Re: OPB 2021-012886-000-00-LU

I saw that you're listed as the staff contact for OPB's Type III Design Review for their property at 7140 S Miles St.: https://www.portlandmaps.com/detail/permit/2021-012886-000-00-LU/4650267_did/

OPB LU 21-012886 DZM GW additional modifications needed

(A) OPB's one-way proposal

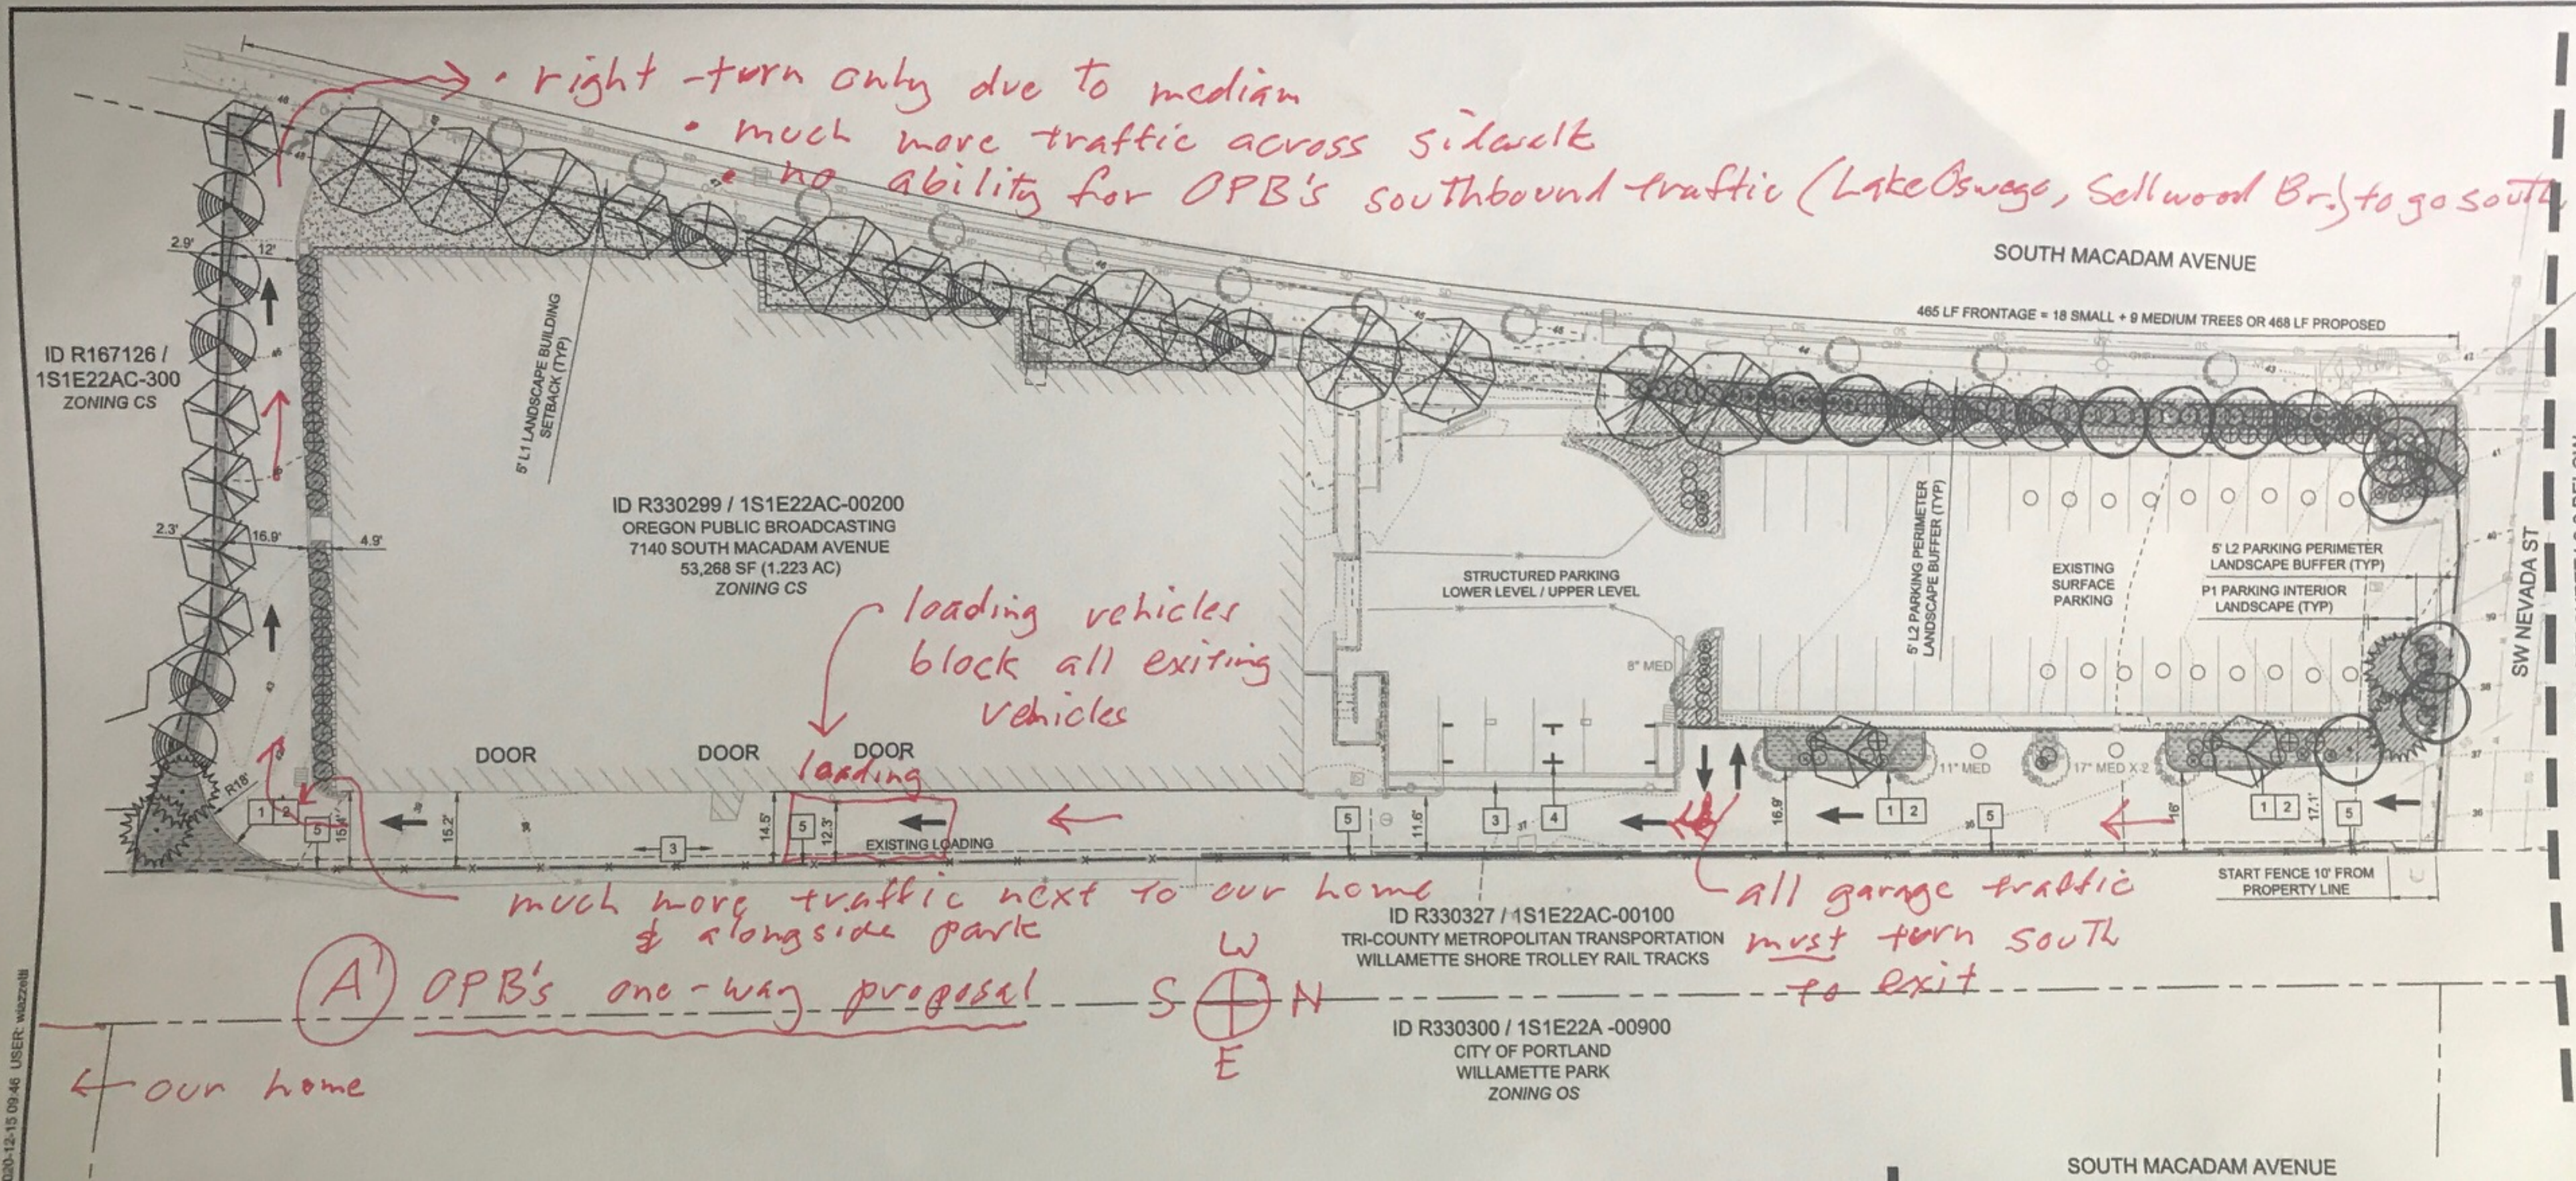
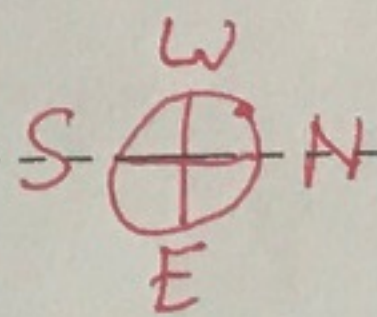
One of the things I thought was worst about OPB's proposal was its plan to change the east driveway to be entirely one-way. (Currently it's only one-way south of the lower level parking garage entrance/exit, and two-way between there and Nevada.)

If you want a quick understanding of why the one-way only driveway is bad, the attached site plans show all the main points at a glance. You don't need to read the rest of this unless OPB continues to pursue the one-way driveway when it submits new info to you.

much more traffic next to our home
& alongside park

all garage traffic
must turn south
to exit
